**Application for Permission Under Section 16 of the Town Planning Ordinance (Cap. 131) for Proposed Temporary Educational Institution (Teaching Farm) and Associated Excavation of Land for a Period of Three Years at Various Lots in D.D. 16, Wo Tong Pui, Tai Po, New Territories
(Planning Application No. A/NE-LT/794)**

Submission of Further Information

Responses to Comments – Departmental Comments (September 2026)

Figure 2.3 Proposed Plant Locations

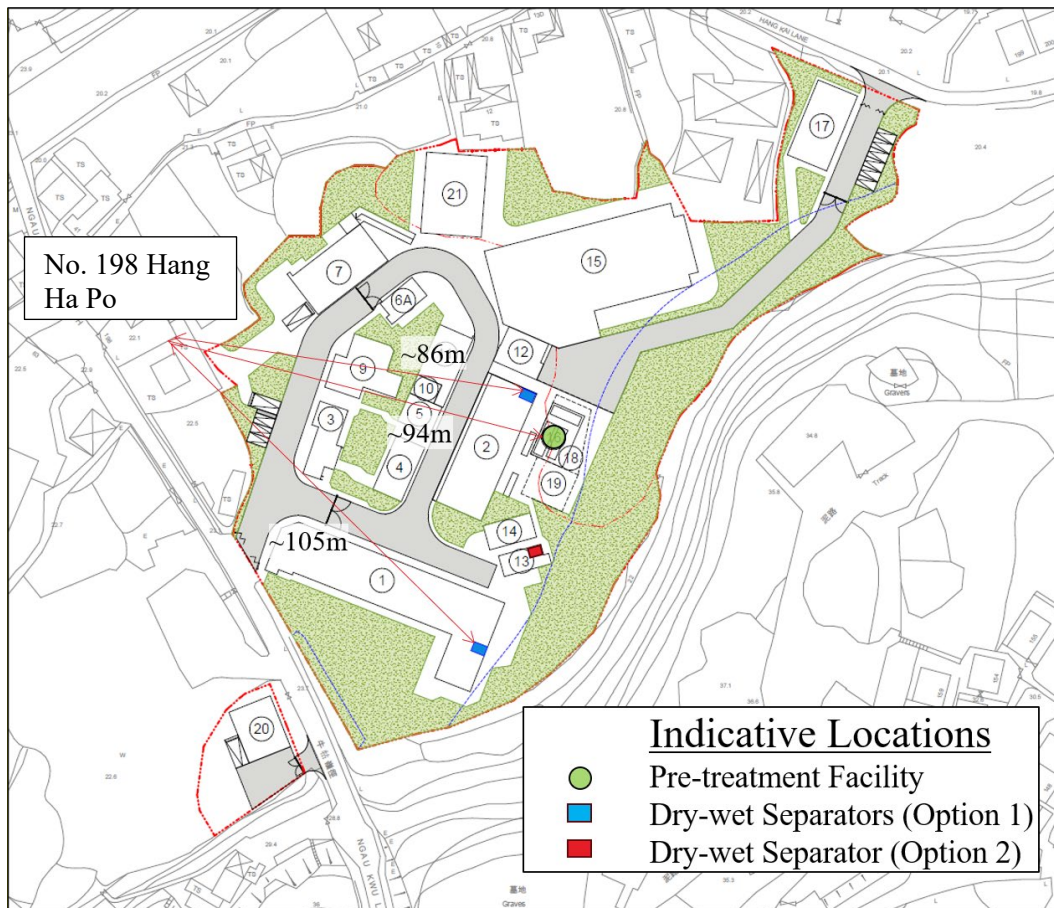
No.	Comments	Responses
2.	Environmental Protection Department, dated 19 August 2026 EPD has the following comments on the submitted Appendix D Environmental Assessment: <u>Noise</u> 1. Table 2.2: Compared to the pre-submission received in May 2026, the remark “The proposed Block 16 will be uncovered structures on ground floor.” has been added for the Pre-Treatment Facilities in Table 2.2. Please clarify the design and address whether there is any potential fixed noise impact on the nearby Noise Sensitive Receivers (NSR) from the proposed uncovered Pre-Treatment Facilities. <u>Water Quality</u> 1. Please review the header of Table 4.6. 2. Figure 4.3: Please review the description “Provide 20mins retention to 10% of maximum runoff a 1-2 year rainstorm” as it seems not quite tally with description in paragraph 4.5.7 and also Figure 3-1 of Appendix E Drainage and Sewerage Impact Assessment. Please also clarify if “1-2 year rainstorm” should read as “1-in-2-year rainstorm”. <u>Waste Management Implications</u> 1. Section 5.2.24: please review if the average general refuse generated per day should be 0.28m³. 2. Table 5.7: please review if the estimated waste quantity to be reused on site for inert C&D materials and non-inert C&D materials should be 778m³ and 141m³ respectively; and suggest to revise the title of row 3 as “Estimated Waste Quantity to be reused on-site” .	Noted. Please refer to the responses below and Appendix B for the replacement pages of the updated Environmental Assessment (EA). The potential fixed noise impact arising from the proposed wastewater pre-treatment facility and dry-wet separators have been assessed and the assessment results have been supplemented in Section 2.4. The facilities are low-height structures located at ground level and are screened by intervening buildings and terrain from nearby NSRs. Please be advised that the header of Table 4.6 has been updated as “Wastewater and Sewerage Loading Estimations”. Noted, Figure 4.3 has been updated and aligned with the latest Figure 3-1 of the Drainage and Sewerage Impact Assessment. The description in Paragraph 4.5.8 has been updated in accordance with the proposed stormwater management as illustrated in Figure 4.3. Noted and updated accordingly. The average general refuse generated per day should be 0.28m³. Noted and updated accordingly. The estimated waste quantity to be reused on site for inert C&D materials and non-inert C&D materials should be 778m³ and 141m³ respectively. The title of row 3 is updated accordingly.

2.4.1 As mentioned in **Section 2.2**, wastewater pre-treatment facilities and dry-wet separators, will be provided for manure handling to improve wastewater management. Under the current design as shown in **Figure 2.3**, the wastewater pre-treatment facility is proposed at Block 16, which comprises an uncovered structure located on the ground floor. Either two dry-wet separators will be installed within the existing beef cattle barn (Block 1) and young stock barn (Block 2), or one dry-wet separator will be installed within the existing Block 13. The final arrangement will be determined during the detailed design stage. For

2.4.2 For Option 1, the two proposed dry-wet separators would be located in a semi-enclosed area. Moreover, the wastewater pre-treatment facility will be below 2 m high and located at ground level, which is lower than the existing and proposed nearby structures, including the Young Stock Barn (Block 2), Store (Block 12), Dairy Barn (Block 15) and Accommodation Block (Block 17), which are approximately 3–9 m high. Together with the intervening terrain, these structures are expected to screen the proposed facilities from the nearby village houses. Consequently, there would be no direct line of sight between the proposed facilities and the neighbour village houses.

Figure 3.2 Buffer Distance from Road to Buildings with Air Sensitive Uses

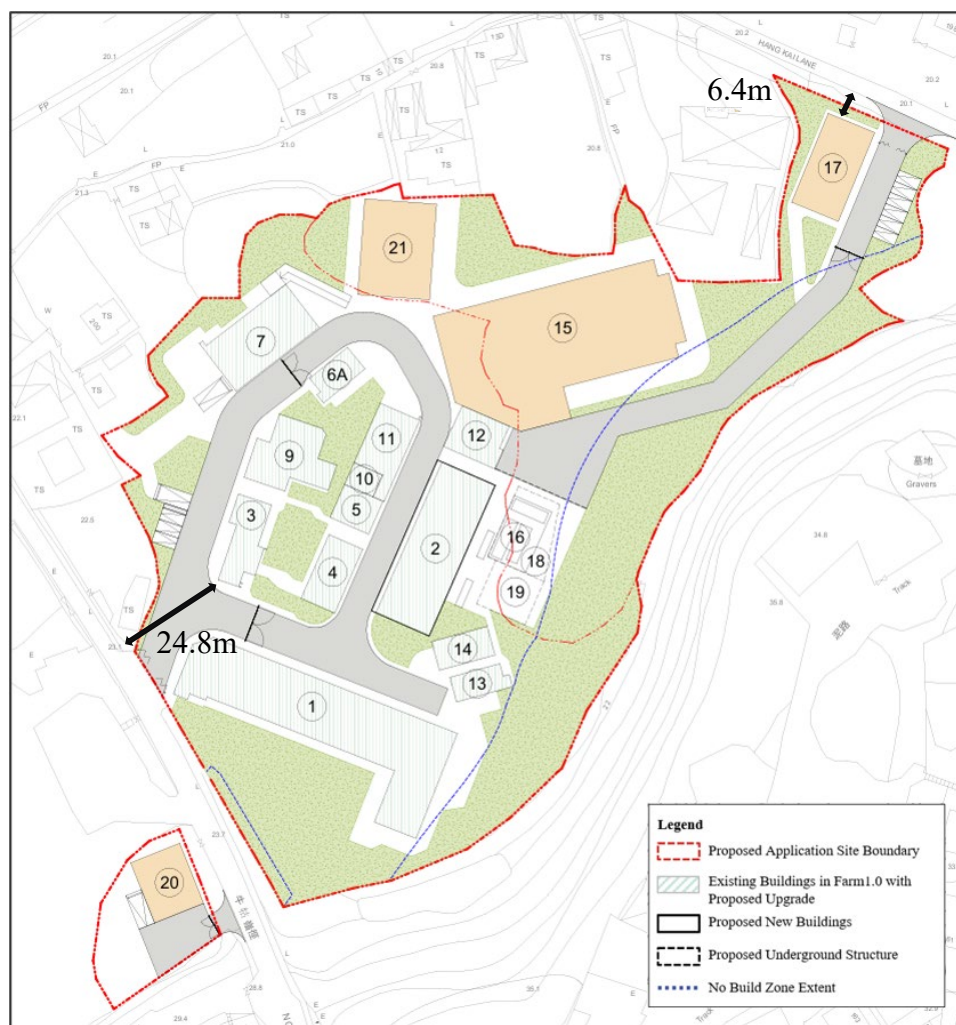
No.	Comments	Responses
3.	Environmental Protection Department, dated 20 August 2026 EPD has the following comments on the submitted Appendix D Environmental Assessment: <u>Air Quality</u> 1. Section 3.1.1: Please confirm whether the Development Bureau Technical Circular (Works) are applicable to this project. According to the RtC, they are expected to be removed, but remains in the list of applicable legislations, standards and guidelines. 2. Table 3.3: - please confirm if CO is measured in Tai Po AQMS in 2025. If not, please indicate with "-"; and - please revise the last sentence of note [3] to read "Number of exceedances allowed per calendar year under the AQOs is shown in ().". 3. Table 3.4 to 3.5 and Section 3.2.5: Please confirm whether annual FSP for grid 37,49 exceeded AQO and update the text accordingly. 4. Table 3.6 and Figure 3.1: - the last comment was not addressed properly. The ASRs should be drawn at the locations closest to the site, especially for larger structures such as ASR17; and - please measure the distances without rounding to the nearest 10m. 5. Section 3.5.1: - please demonstrate, using a figure, that the required buffer distance is met for all buildings with air sensitive uses; and	Noted. Please refer to the responses below and Appendix B for the replacement pages of the updated EA. Noted, the Development Bureau Technical Circular (Works) have been removed from the list. Noted, it has been updated accordingly with "-" indicated. Noted, it has been updated accordingly. Noted, please be advised that the annual FSP for grid 37,49 does not exceed AQO and the text has been updated accordingly. Noted, Table 3.6 and Figure 3.1 have been updated accordingly. Noted, the distances in Table 3.6 have been updated accordingly without rounding to the nearest 10m. Noted, Figure 3.2 has been supplemented to demonstrate the buffer distance from road to buildings with air sensitive uses.

No.	Comments	Responses
	- please justify the 5m setback is adequate (e.g., with Transport Department’s confirmation that the road class is local distributor or below). 6. Section 3.5.14 & RtC #11 (Page 14 of the RtC Table): Please clarify where “Attachment A” is provided. 7. Section 3.5 & RtC #12 (Pages 14-15 of the RtC Table): Please provide further information, such as the reliability of the proposed system, to justify that odour will be better managed.	Noted, please be advised that the following road classification have been confirmed by Transport Department (TD): • Hang Kai Lane (Local Distributor or below) • Ngau Kwu Leng Path (Local Distributor or below). Please refer to Appendix C for the confirmation email from TD on road type classification. Please be advised that “Attachment A”- “Micro-Nano Deodorization Technology Description” of the Responses-to-Comments (RtC) during the pre-submission stage does not form part of the Environmental Assessment Report and is attached for reference only to justify the proposed removal efficiency. Please refer to Appendix D for the “Micro-Nano Deodorization Technology Description” for reference. Please refer to Appendix D for the “Micro-Nano Deodorization Technology Description” for further information on the proposed system for odour control.

receivers (buildings). Accordingly, the buffer distances for roads/highways and industrial areas/chimneys recommended in the HKPSG, as listed in **Table 3.2**, are satisfied.
